# CITY PLANNING COMMISSION

- APPLICATION:
1. Negative Declaration
  2. Point West PUD Schematic Plan Amendment from Light Industrial to Office Designation;
  3. Rezoning from Light Industrial-Review Parkway Corridor (M-1(S)-R PC to Office Building-Review Parkway Corridor (OB-R PC);
  4. Special Permit to develop a 24,650± square foot office building on 1.4± vacant acres in the Office Building-Review Parkway Corridor (OB-R PC) zone and the Point West PUD;
  5. Special Permit to allow a detached monument sign in addition to a 64 square foot attached sign;
  6. Plan Review for a 24,650± square foot office building.

APPLC. NO. P84-151

STAFF EVALUATION: Staff has the following comments and concerns:

PRELIMINARY  
**LANDSCAPE PLAN**

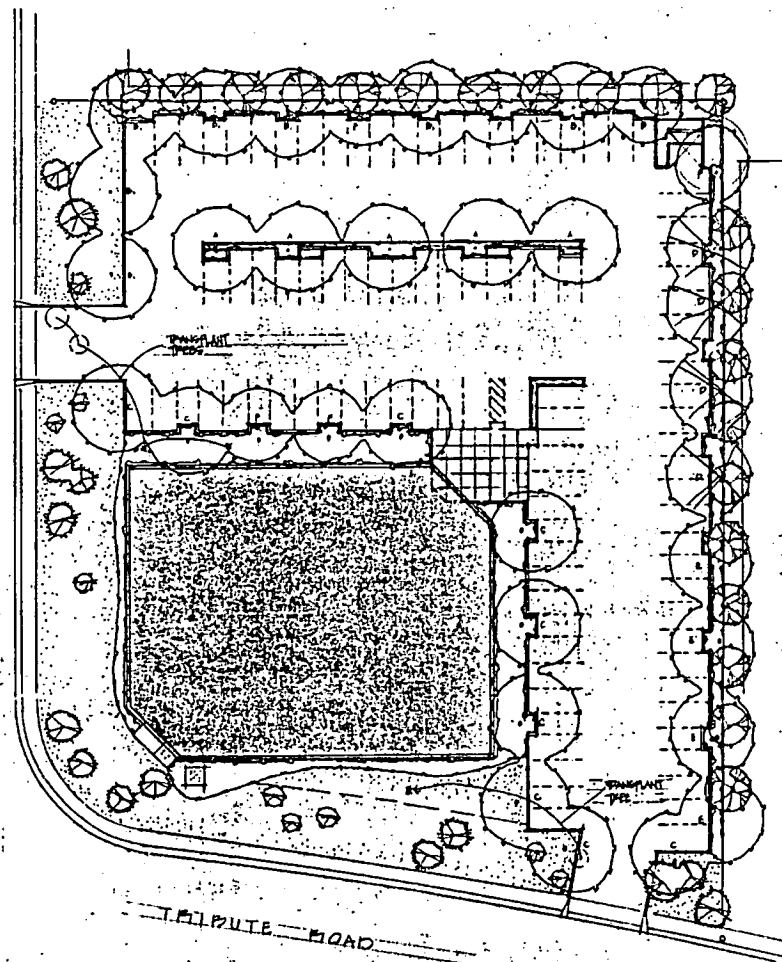
- 4) The Committee also recommends that additional landscaping be added at the southwest corner of the site to more fully balance the landscaping design as provided for the balance of the property. A more detailed plan of the entire site should be submitted to the Committee for their review prior to occupancy certificate;

- 5) At the east property line it is suggested that the landscaping plan be modified to be compatible with the mature trees on the adjacent properties. With the assistance of the mature trees, the landscape budget could be shifted to more fully landscape the remainder of the site.

6. A detailed landscape, irrigation and parking lot shade plan must be reviewed prior to building permit issuance. The tree shading plan may be able to utilize the shade trees planted along the common easterly property boundary.

SOUTH ELEVATION  
1/8" = 1'-0"

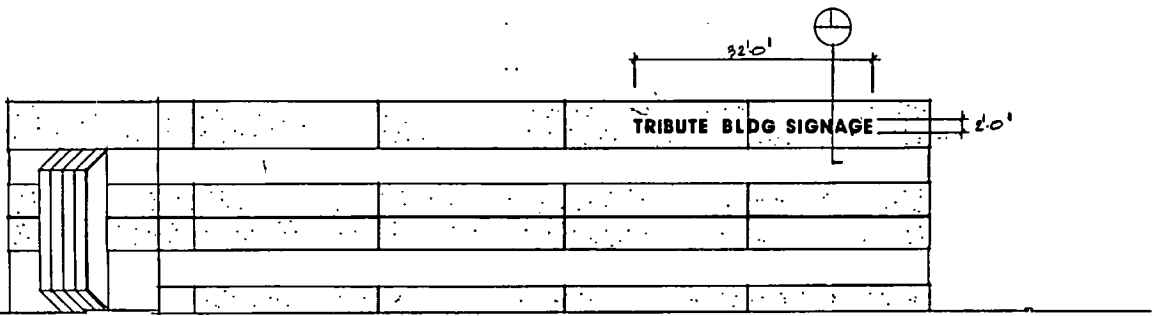
10. The submitted elevations indicated one attached sign (2' x 32') on the south elevation and one monument sign (3'6" x 5'). The Sign Ordinance and the Point West Sign Guidelines allows only one sign. Staff discussed this sign issue with the applicant who indicated that the attached sign will be eliminated from this proposal. However, the applicant proposes to utilize the proposed monument sign and provide tenant identification. The Sign Ordinance and Point West Sign Guidelines allow one monument sign not to exceed six feet in height. The applicant, however, should be aware that the Sign Ordinance requires that detached signs, when located in the OB zone, cannot be located in the building setback areas. The Point West Sign Guidelines, however, require a 10-foot setback for detached signs. The applicant therefore will have to apply for a variance from the Commission prior to issuance of the sign permit.

BLDG. HEIGHT SIGHTLINE ELEVATION  
1" = 20' 0"

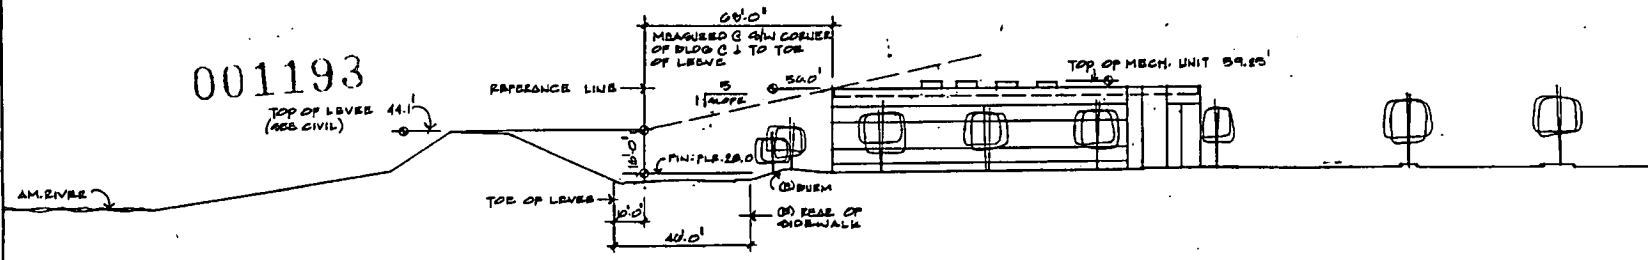
4. The Point West Architectural Review Committee is concerned with increasing the parapet height to reduce visibility of mechanical equipment. Submitted site plans indicate the building just clears the maximum height allowed at its closest point to the parkway; therefore, no additional height can be allowed at that point. However, farther north on the building the allowed height may increase according to the formula specified in the American River Parkway Ordinance.
